**AGENDA**  
**CASCADE CHARTER TOWNSHIP PLANNING COMMISSION**  
**MONDAY, May 19, 2025**  
**6:00PM**  
**2870 JACKSMITH AVE SE**

**Case #25-3885 – Public Hearing**

## PLANNING COMMISSION STAFF REPORT

STAFF REPORT: Case # 25-3885  
REPORT DATE: May 14, 2025  
PREPARED FOR: Cascade Charter Township Planning Commission  
MEETING DATE: May 19, 2025  
PREPARED BY: Andrea Hendrick, Community Planning & Development Director

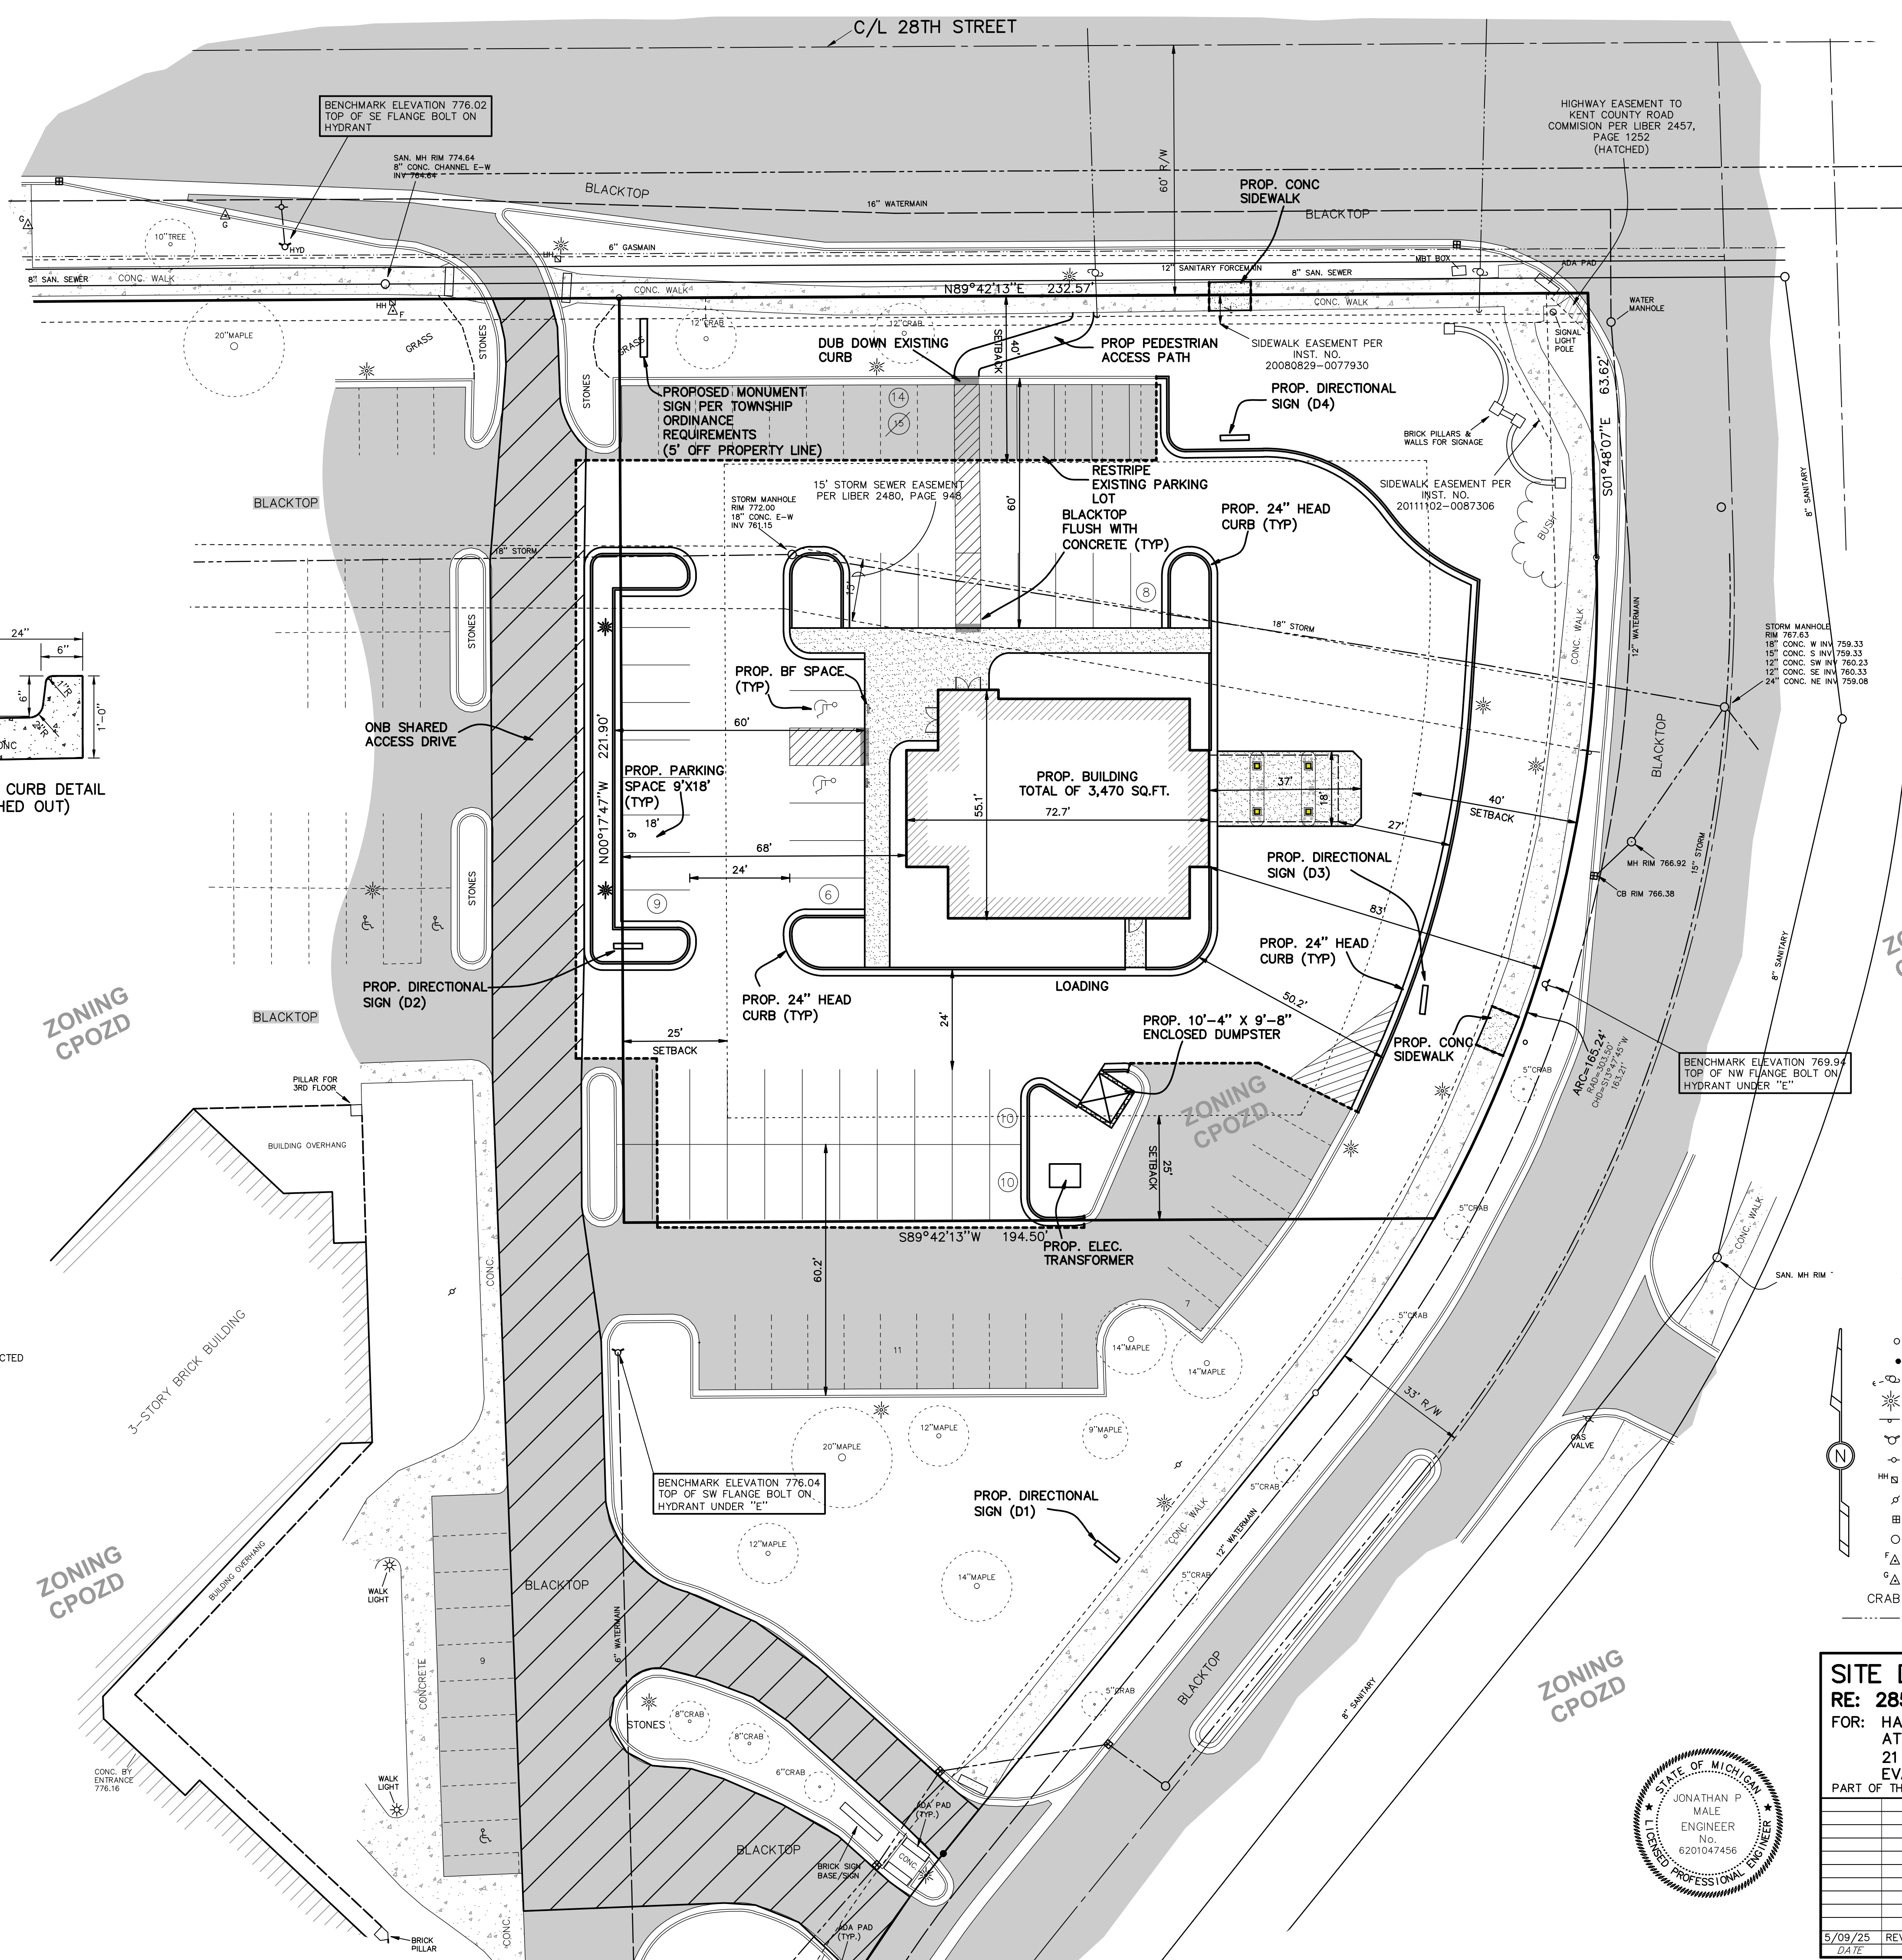
<p>6. Parking</p> <ul style="list-style-type: none"> <li>a. Off-Street Parking – Setbacks Right-of-way: 40 feet Side &amp; Rear: 25 feet</li> </ul>	<p>Nonconforming off-street parking within the setbacks currently exists in the north portion of the parcel facing 28<sup>th</sup> Street. This was previously addressed in Subsection 2 above. The Planning Commission shall determine if the site shall comply with the current standards for redevelopment.</p>

Staff have calculated that the minimum required parking for both the existing bank and the proposed office building are adequate to serve both uses. If the Planning Commission determines that the nonconforming parking within the setback is not appropriate, the minimum parking requirements will not be met.

- The current parking spaces on the north side of the site are built within the existing forty (40) foot setbacks and are not compliant with the greenspace requirements. While this area is uninterrupted, and it could be argued that maintaining the parking spaces would be a continuation of a nonconformity, the Planning Commission also has the authority to require that the setbacks and open space requirements are met. The Planning Commission should deliberate and determine if the current parking is appropriate to remain as part of the development.
- The Planning Commission has the authority to modify the planting requirement for the bufferyards. The Planning Commission should deliberate and determine if it is appropriate for the applicant to disperse the plant material throughout the site.

1. The existing non-conforming parking spaces abutting 28<sup>th</sup> Street on the north side of the site may remain.
2. The required bufferyard plant material may be dispersed throughout the site.
